- Subject : Bolt of landing gear control interfering with control pushrods
- Effectivity : Type: DG-800, only variant DG-808C, all ser. No.'s
- Accomplishment : Prior to next flight

**Photo 2: Bolt installed in wrong direction, pushrod 6St13 damaged**

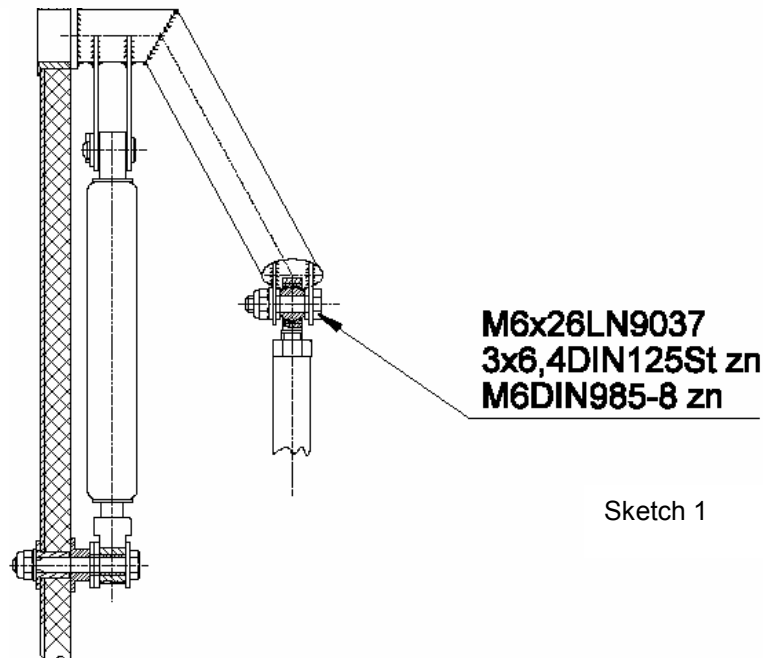
- Reason : Owners found on a DG-808C that the bolt at the landing gear control bellcrank was mounted in the wrong direction and could interfere and damage the air brake push rod in the mid fuselage section. If the landing gear is operated with negative flap settings in addition the wing flap pushrod may be damaged.

3. If the bolt is mounted in the wrong direction as shown in the photo 2 on page 2 remove the bolt and install in the correctly.  
4. Check if push rod 6St13 (airbrake control) and 8St7 (wing flap control) are damaged. Replace if necessary.

- Instructions : 1. Derig the glider and remove the left baggage compartment floor.  
2. Check the direction of the bolt M6x26 LN9037 see MM diagram 15, section A-A or sketch 1 below. If the bolt is mounted correctly no further actions are necessary.
